Why `cumulativeScaledRateOffset` is important - also for TC like operation

Christian Boiger
christian.boiger@b-plus.com

Example 1

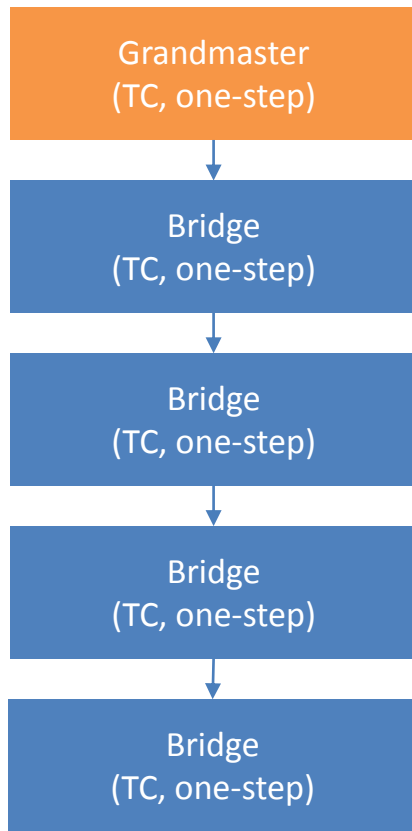
| Neighbor Rate Ratio | Rate Ratio relative to GM | cumulativeScaledRateOffset | Residence Time | Accumulated Error* |
|---------------------|---------------------------|----------------------------|----------------|--------------------|
| +100 ppm | +100 ppm | 0 ppm | 400 μ s | 40 ns |
| 0 ppm | +100 ppm | 0 ppm | 400 μ s | 80 ns |
| 0 ppm | +100 ppm | 0 ppm | 400 μ s | 120 ns |
| 0 ppm | +100 ppm | 0 ppm | 400 μ s | 160 ns |

* accumulated time synchronization error due to wrong cumulativeScaledRateOffset

Example 2

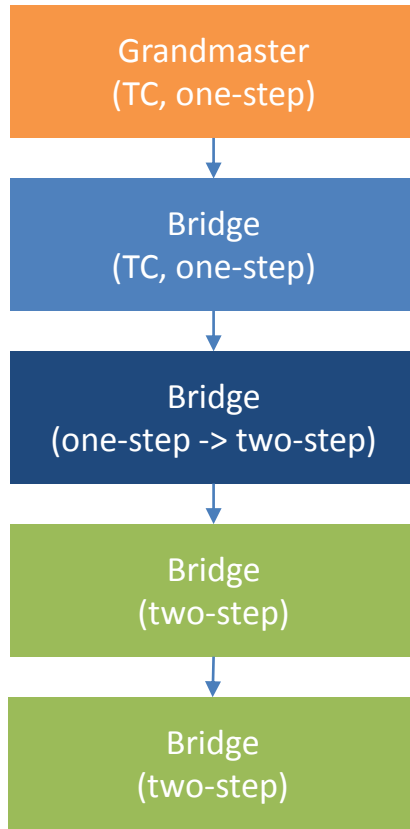
| Neighbor Rate Ratio | Rate Ratio relative to GM | cumulativeScaledRateOffset | Residence Time | Accumulated Error* |
|---------------------|---------------------------|----------------------------|----------------|--------------------|
| +100 ppm | +100 ppm | 0 ppm | 400 μ s | 40 ns |
| -100 ppm | 0 ppm | - 100 ppm | 10 ms | 960 ns |
| 0 ppm | 0 ppm | - 100 ppm | 10 ms | 1960 ns |
| +100 ppm | +100 ppm | 0 ppm | 10 ms | 2960 ns |

* accumulated time synchronization error due to wrong cumulativeScaledRateOffset

- In TC only networks the error due to not updating `cumulativeScaledRateOffset` is “small” but not negligible especially in large networks or networks with higher residence times e.g. 100 Mbit/s networks (errors $\gg 100$ ns are possible)
 - In mix networks (TC, one-step, two-step) the resulting time synchronization error is huge (errors $\gg 10$ μ s are possible)
-
- ➔ A correct `cumulativeScaledRateOffset` is essential to provide accurate time synchronization
 - ➔ The time synchronization errors due to incorrect `cumulativeScaledRateOffset` information are not acceptable
 - ➔ Even in a TC-like one-step AS mode, the `cumulativeScaledRateOffset` needs to be updated
